**Software Release Notice
Developed or Modified Software**

1. Software Name: Preclosure Safety Analysis (PCSA) Tool		Software Version: 3.0.1 BetaC
2. Software Function: Allow an experienced user to conduct a preclosure safety analysis

SOFTWARE CHANGE REPORT (SCR)

1. SCR No. (Software Developer Assigns): 542	2. Software Title and Version: PCSA Tool, Version 3.0.1 (Beta A)	3. Project No: 20.06002.01.334
4. Affected Software Module(s), Description of Problem(s): CrystalRiskResultsGraph.rpt, CrystalRSACCCDF.rpt, frmCrystalSSC.frm, CrystalSSC.rpt, frmEditTables.frm, mdLYMPModule1.bas, frmSevereEvents.frm, frmInitEvFrmHazIdSel.frm, CrystalSSCDBandDC.rpt, frmSSC_Data, frmSSCFrmHazIdSel.frm See attachment, "Affected Software Module(s), Description of Problem(s)."

Cumulative Distribution Wind Velocity

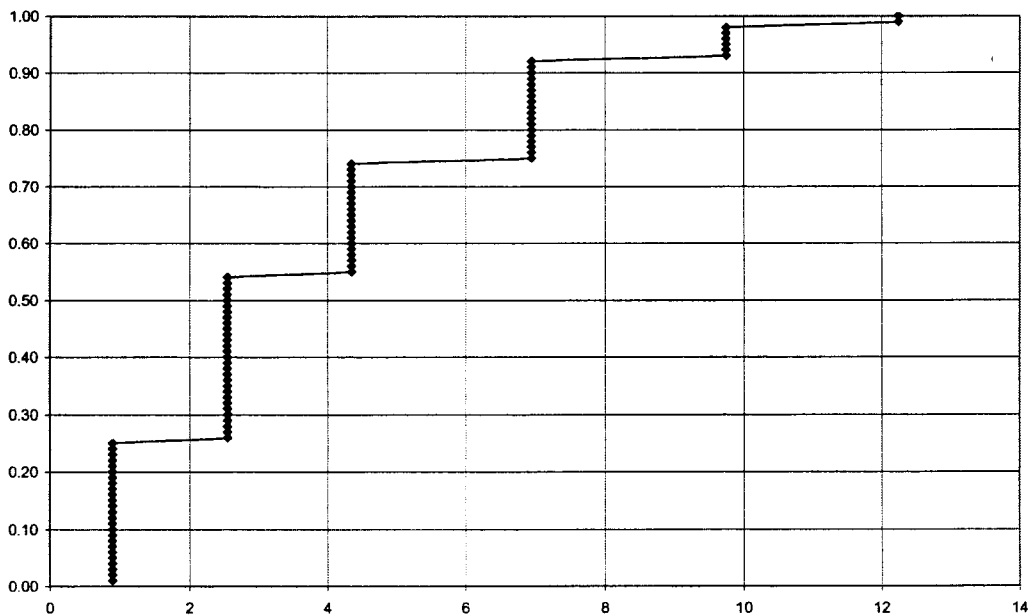
- 14) The deterministic default for wind speed needs to be modified from 3 m/s to 4.3 m/s. The probabilistic defaults for wind speed need to be updated to the following User Supplied Discrete distribution:

- 14) Updated the deterministic default for wind speed from 3 m/s to 4.3 m/s and the probabilistic default for wind speed to a User Supplied Discrete distribution with the following wind speed (m/s), probability pairs: 0.9,0.25 2.55,0.29 4.35,0.20 6.95,0.18 9.75,0.06 12.25,0.02. This change affected tables RSAC Meteorological Data, RSAC_LHS_Table, and WkrRSAC Meteorological Data.

- Test 14: Opened RSAC input file and verified the default value for the wind speed is 4.3 for a deterministic run and the probabilistic case the sample distribution is: 0.9, 0.25 2.55, 0.29 4.35, 0.20 6.95, 0.18 9.75, 0.06 12.25, 0.02. Performed a 100 realization RSAC run and plotted the cumulative distribution of the wind speed from the lhs.out file to view the probabilistic wind speed data.
